VALUE ENGINEERING STUDY

Project # CSSTP-0007-00(692) PI No. 0007692

SR 92 from SR 120 to CR 473/Cedarcrest Road
Cobb/Paulding County, Georgia

31 January 2013

PROPOSAL NUMBER: R-11.0

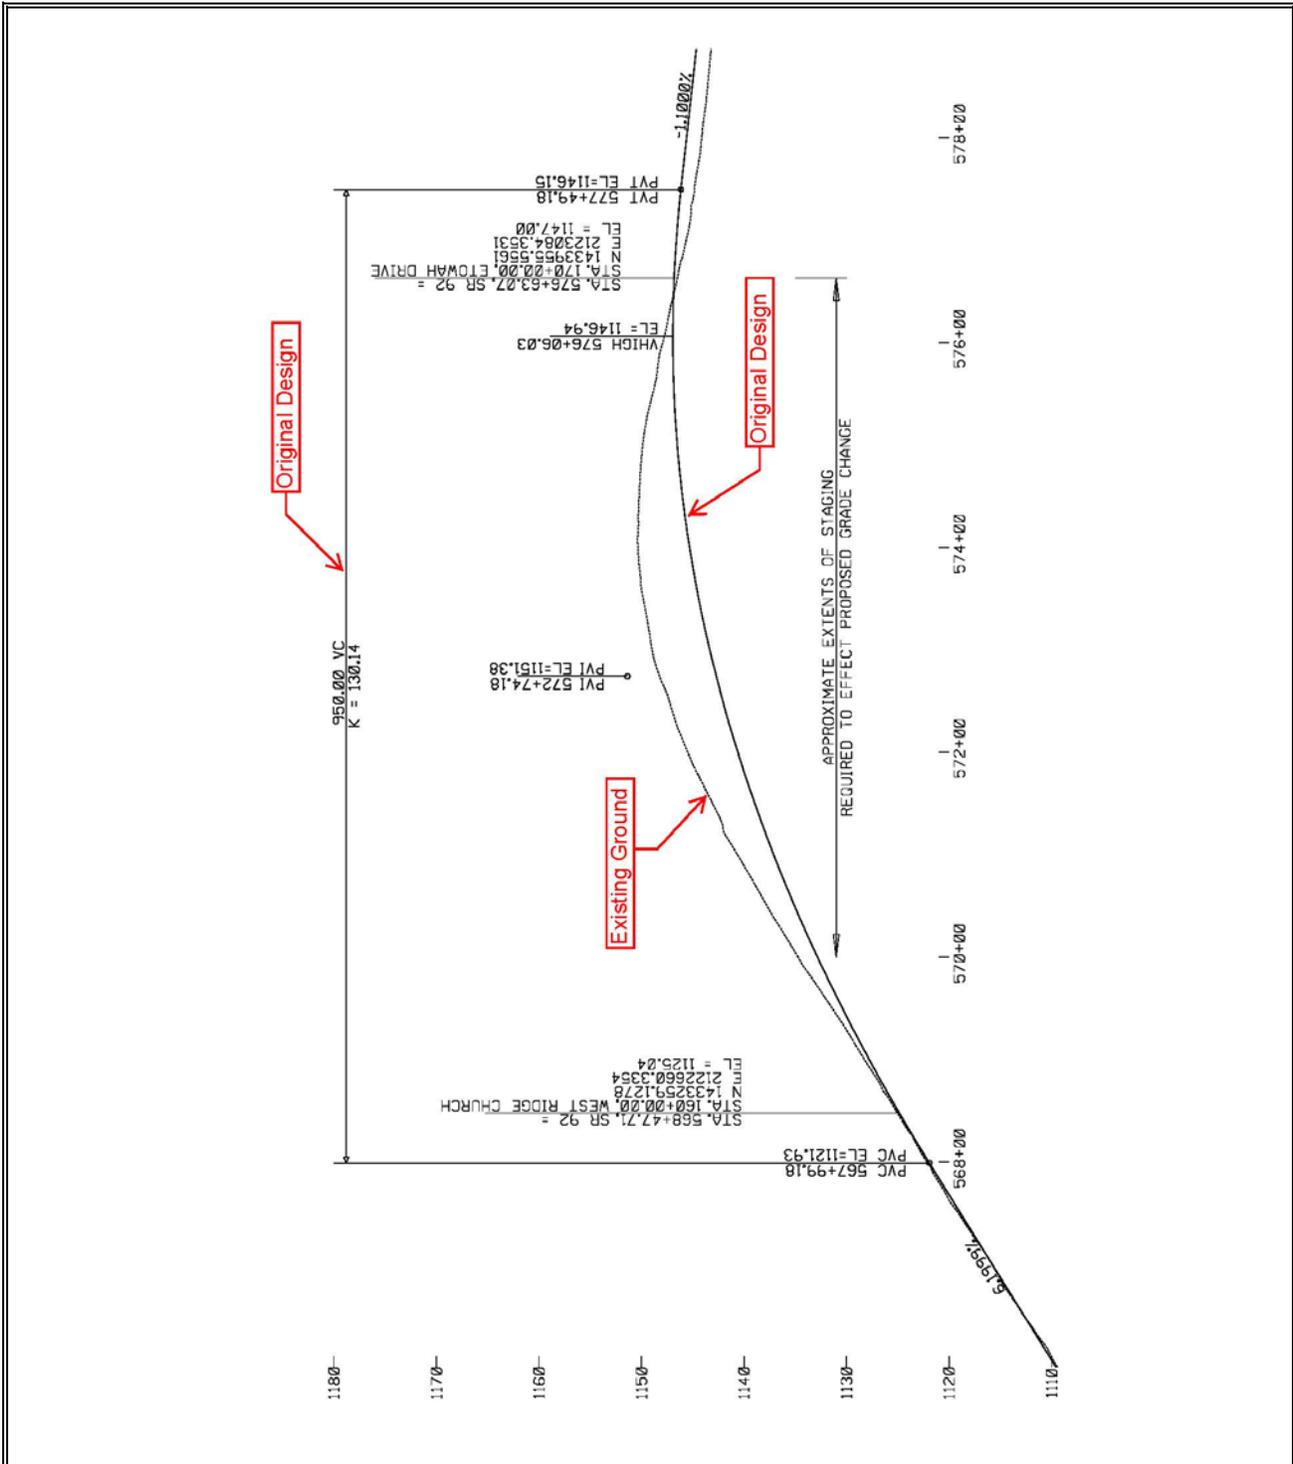
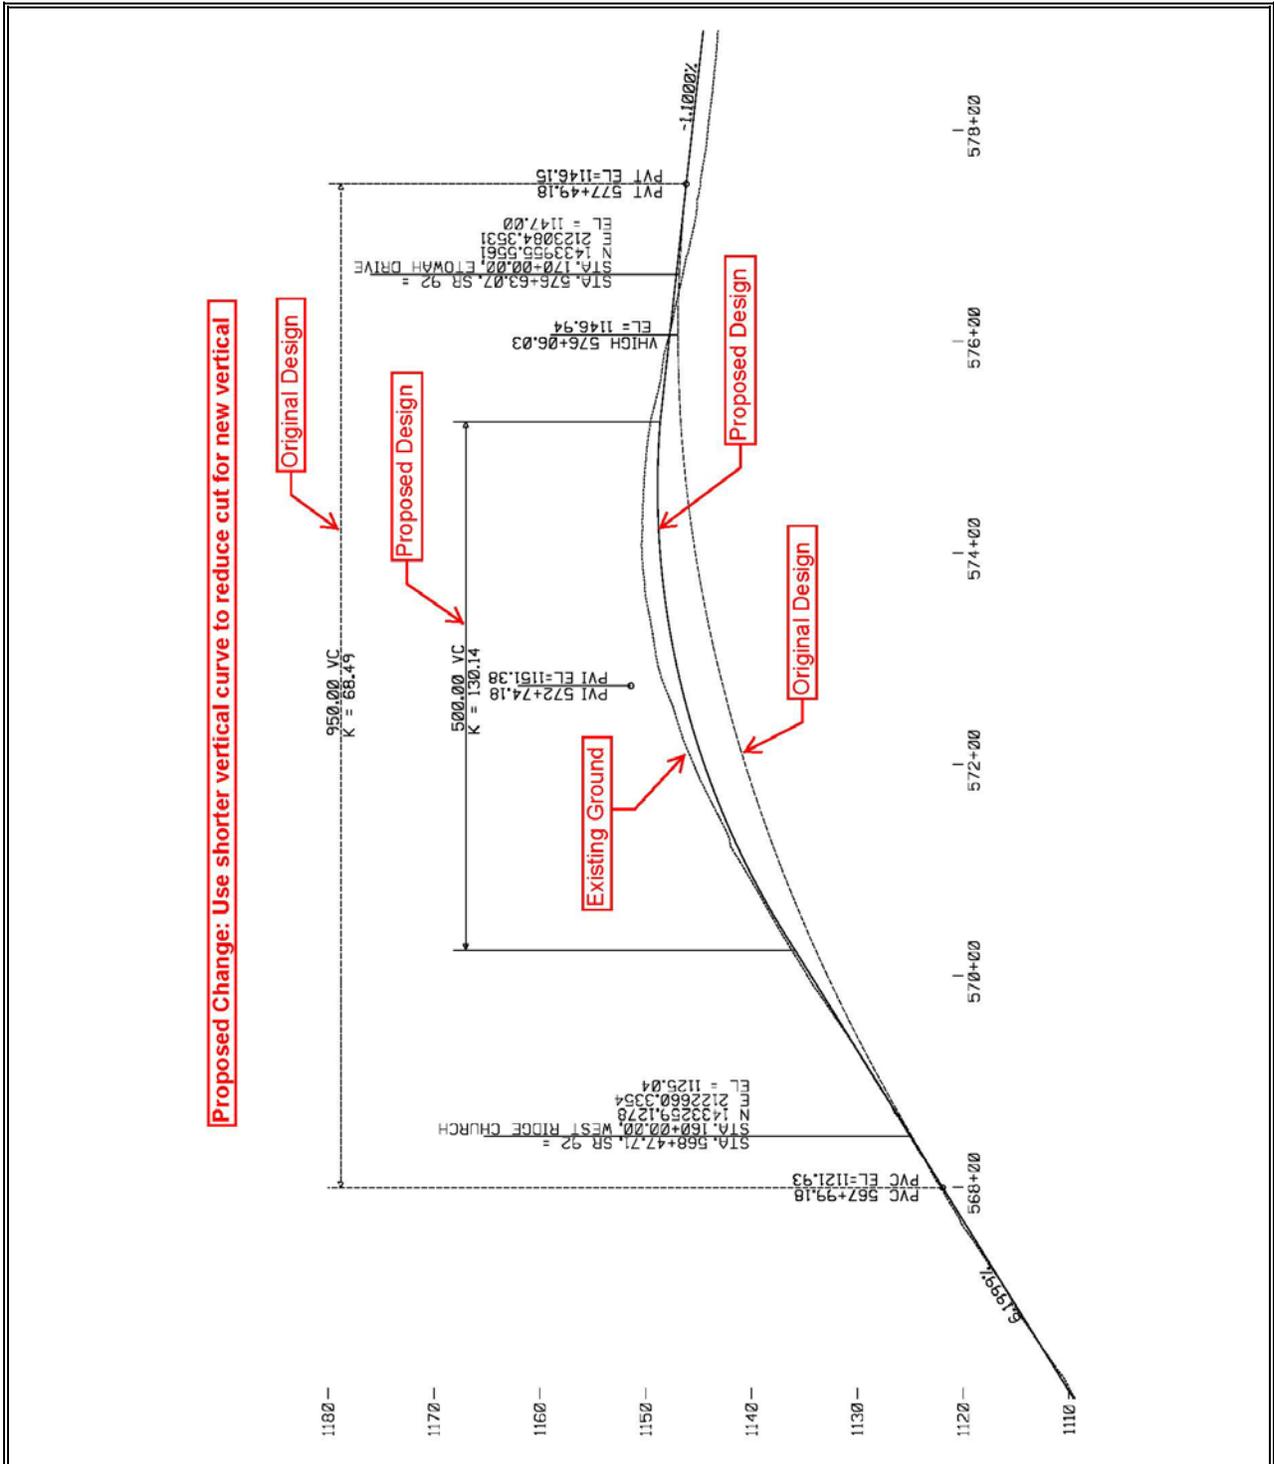
PROPOSED CHANGE: It is proposed to utilize a 500-foot vertical (K value = 68.49) crest curve; the vertical profile grades of 6.999% and -1.100% from the original design are maintained. This design meets the 45 mph design speed and provides approximately 500 feet of intersection sight distance along the vertical profile. This design results in a two foot lowering of the vertical profile from the existing ground at approximate Sta 573+00.

Change is limited to Sta 568+00 to Sta 576+00.

PROPOSAL NUMBER: R-13.0

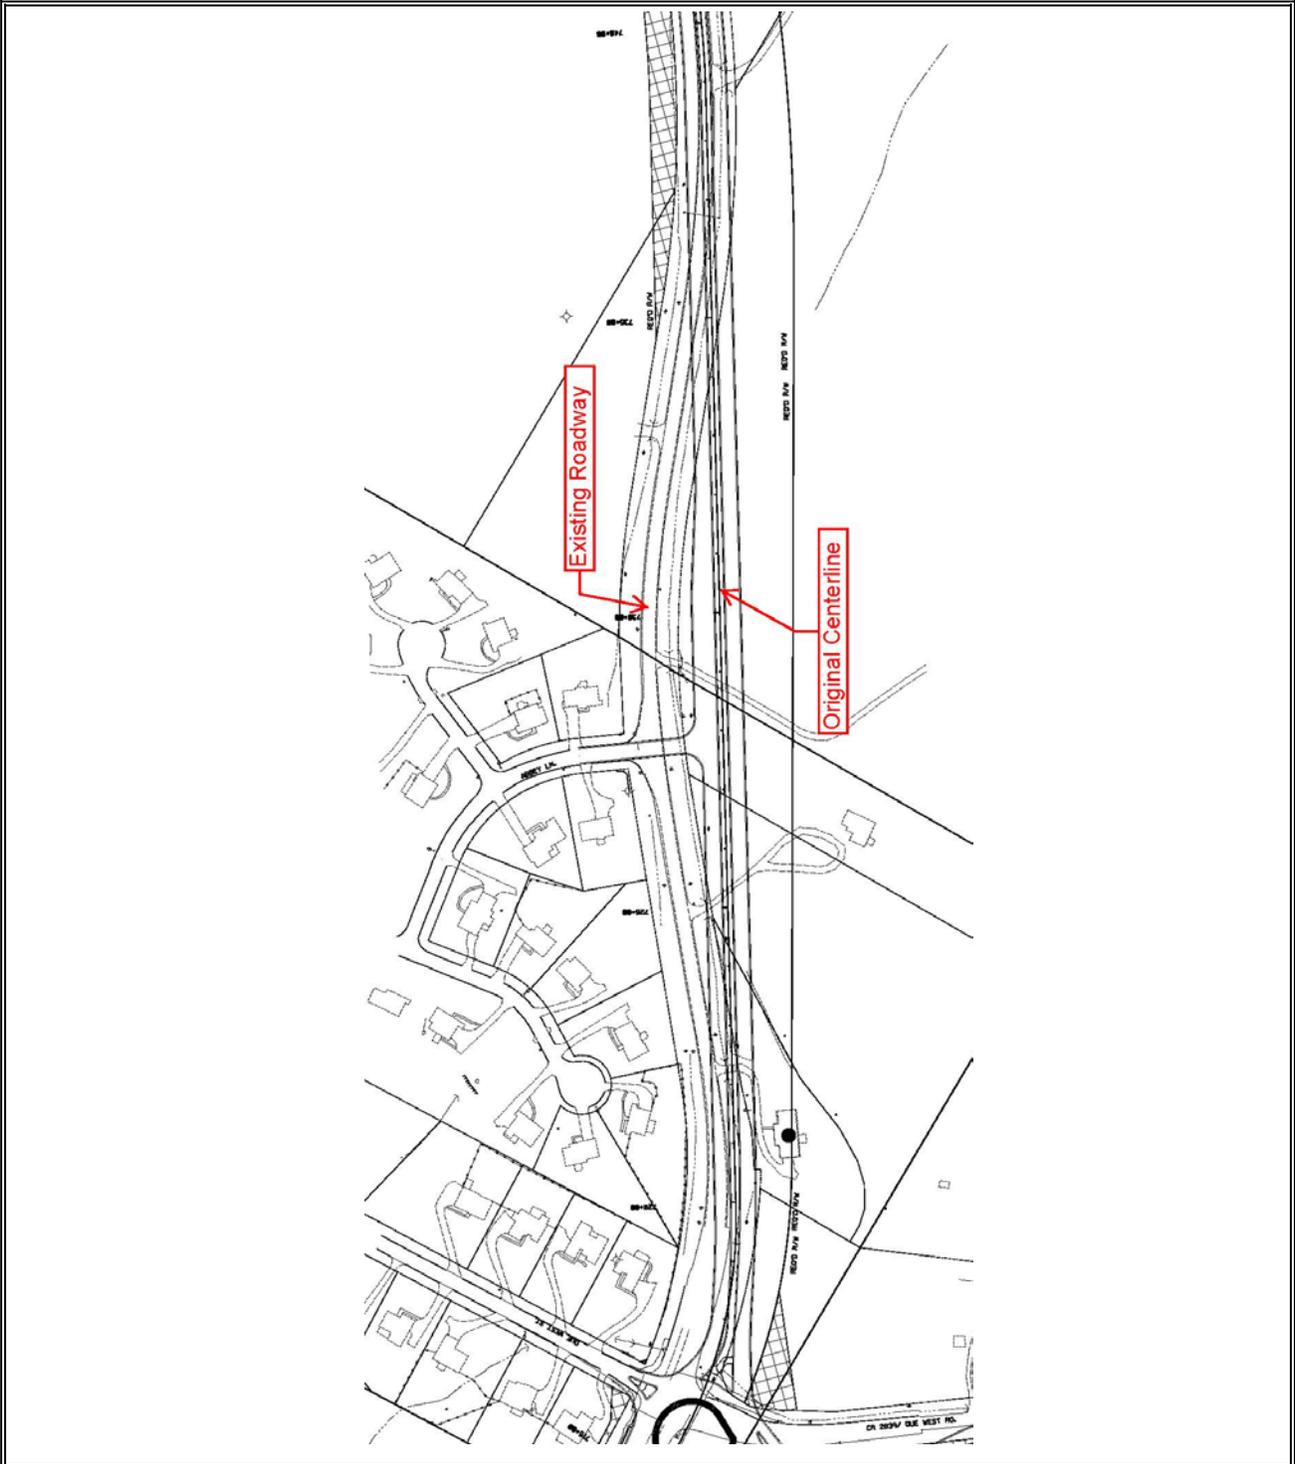
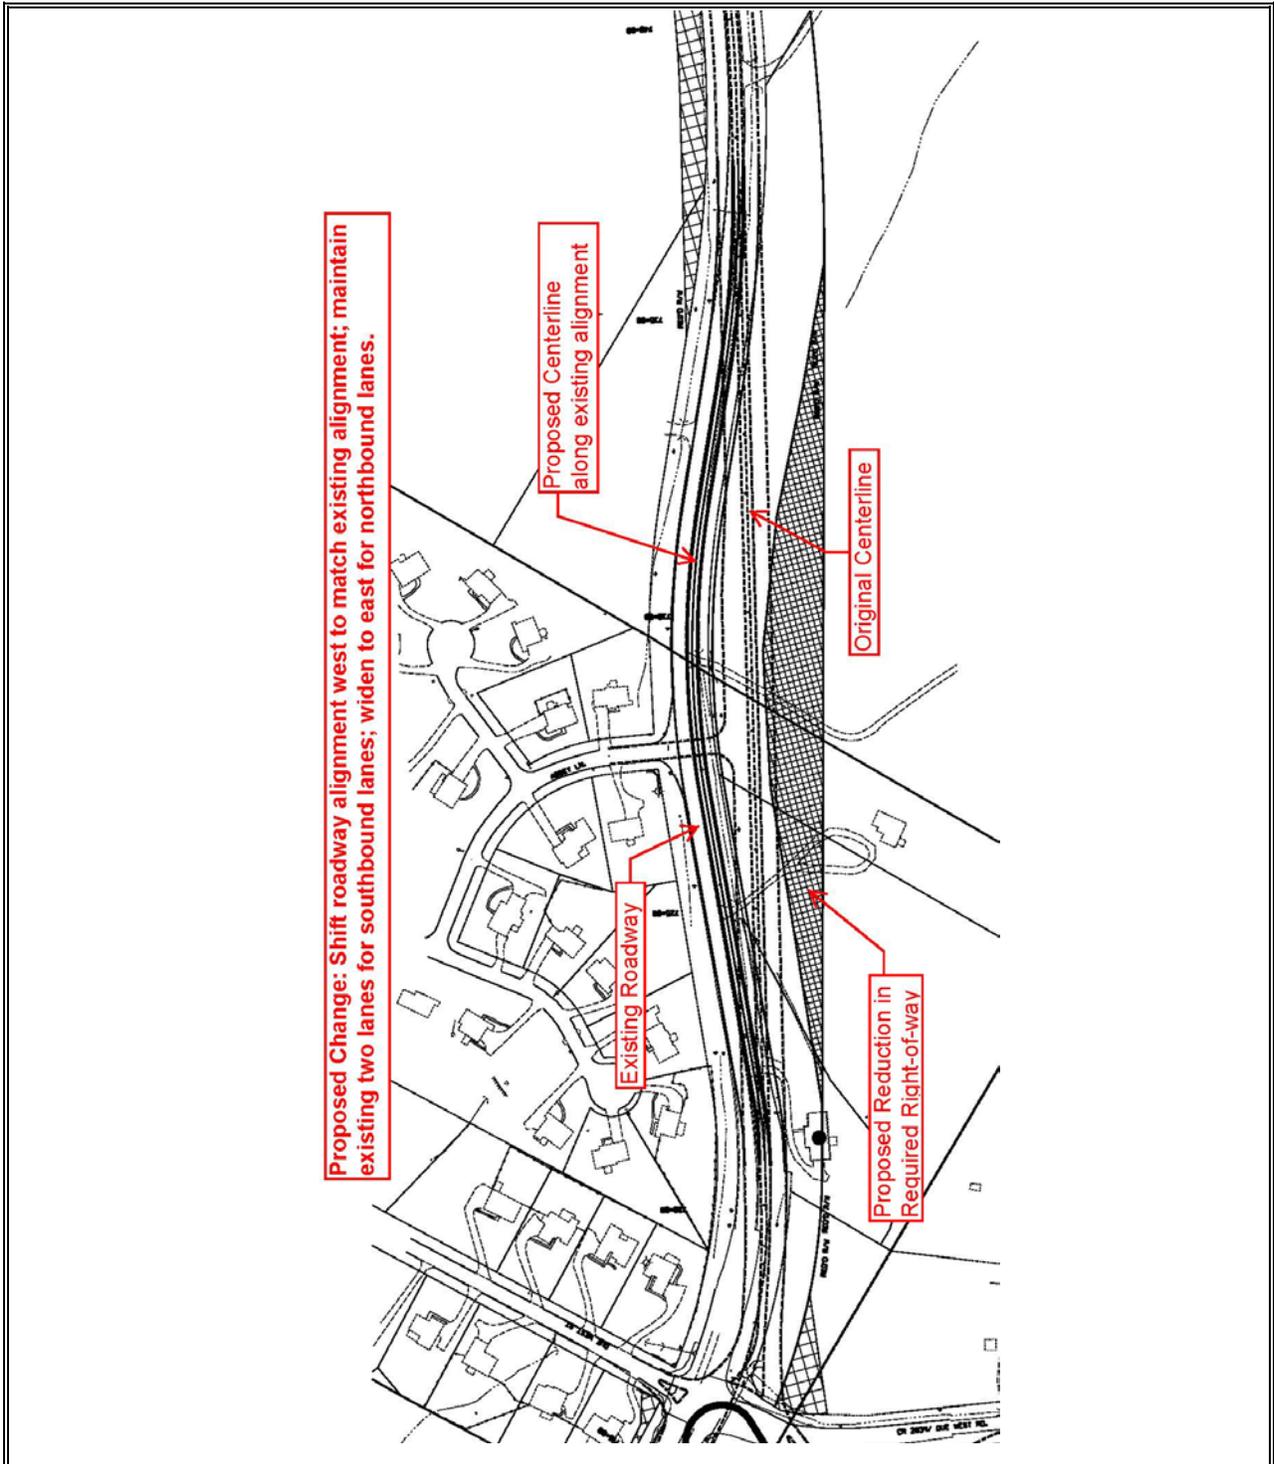
PROPOSED CHANGE: It is proposed to maintain the existing horizontal alignment from Sta 720+00 to Sta 740+00. The existing two lanes would be maintained as the southbound lanes and new northbound lanes would be constructed to the East.

Change is isolated to Sta 720+00 to Sta 740+00 for total length of 2000 FT.
